2202 8th Avenue  
Design Review Board

DPD PROJECT NUMBER: 3016464

Recommendation Meeting: 04.November 2014

## Design Review Board Comment Responses

Blanchard frontage Design Refinement Elevation

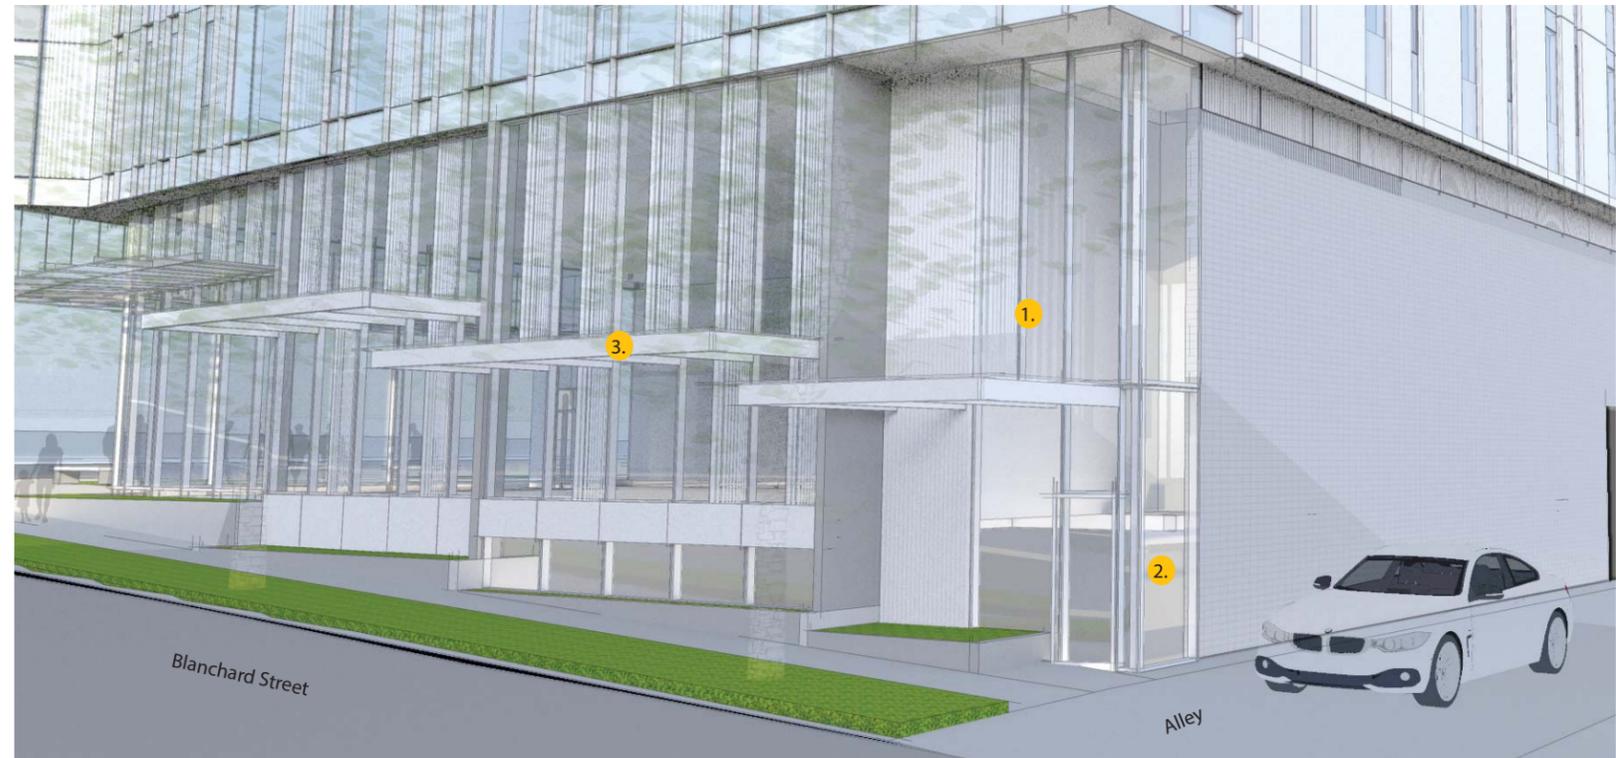
1. Further study at highly visible podium corner.
2. Lobby should have distinct form or recess at ground level.
3. Repeated ellipse shapes and abrupt alley edge need refinement.
4. More commercial doors along Blanchard frontage for long term flexibility and pedestrian engagement.
5. At SE corner, move shaft and stair to make corner more transparent.

1. To create the most flexible restaurant space that will enliven our important SE corner we have set the floor level so that it matches the grades at the intersection of 8th Avenue and Blanchard Street. This creates a pedestrian scale visual connection to corner.
2. The sharp slope of the sidewalk makes the addition of doors along Blanchard restrict the overall flexibility of the retail.
3. Setting the floor height at the level of the intersection also allows us to allow light into the bicycle parking below, maximizing the visual transparency for the pedestrian.

Massing Adjustment

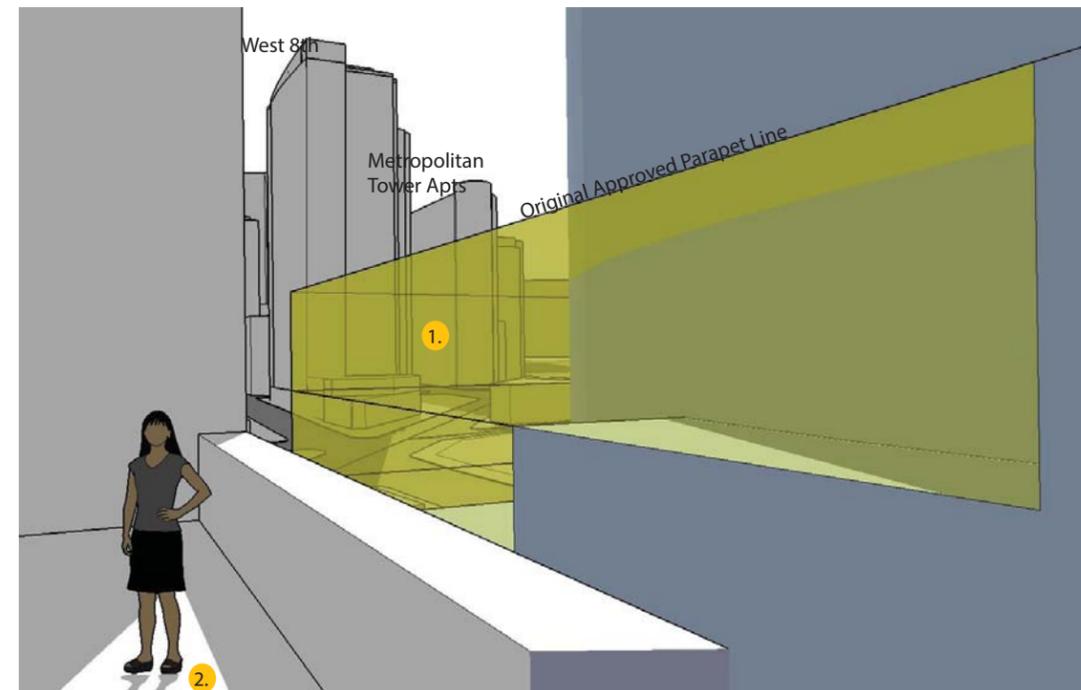
1. The alley facade should be carefully designed with sensitivity to the adjacent Enso units to limit eye to eye privacy issues.

1. Concern about loss of light and air to residential units across alley.
  - a. Top three floors of alley facade are now stepped and terraced to maximize light and air reaching Enso's amenity deck
  - b. Elliptical shape maximizes light penetration and minimizes view blockage
2. Concern about loss of sunlight to existing plants and usability of Enso's amenity deck
  - a. See response to item 1 above.
  - b. Additional sun/shadow studies provided, with terraced alley facade.
3. Loading and parking access will compound an already congested alley
  - a. Garage access is as far as possible from Enso garage entrance
  - b. Garage access is perpendicular to alley; cars can go north or south to avoid congestion
  - c. No public parking is provided, minimizing traffic
  - d. Though no loading dock is required, there are locations for truck parking within the building.

1. Stepping back the facade gives the adjacent Enso amenity deck more opportunity for daylight and views
2. Stepping back the facade gives the adjacent Enso amenity deck more solar access
3. The projects elliptical shape allows for visual access from the adjacent Enso amenity deck to the Space Needle

## Balcony Integration

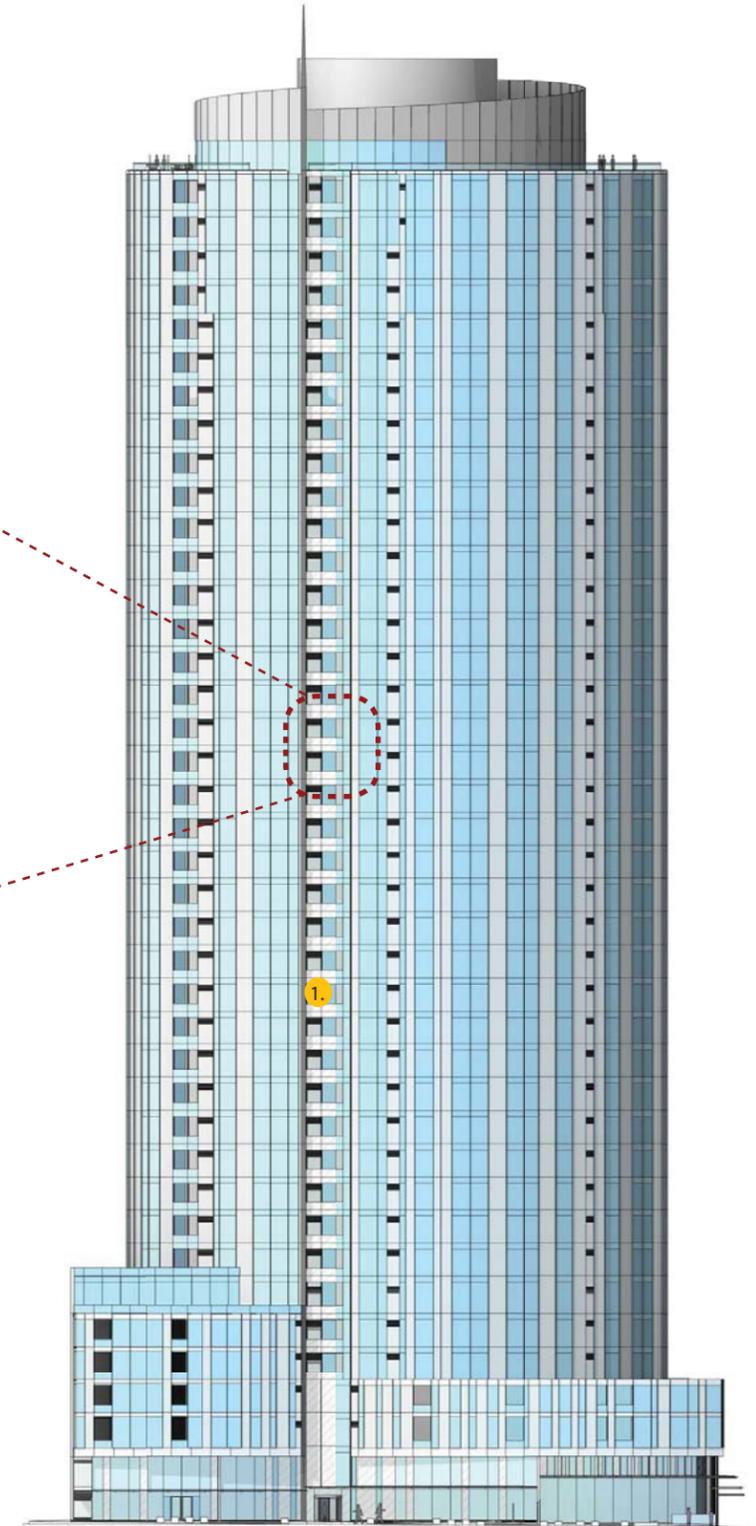
1. Explore composition and materiality that integrates balconies, does not look like an office building, and reflects the layered parti.
2. Composition should represent a transition from skyline scale to pedestrian scale and not assume identical language throughout.

1. The balconies are designed to emphasize the verticality of the design, they are located to provide scale and emphasis to larger scale architectural moves.
2. The balconies include a vertical glass screen to help create a sense of enclosure, and to continue the verticality of the facade.
3. The materiality is consistent with the rest of the design including white metal panel, glass, and fritted glass.
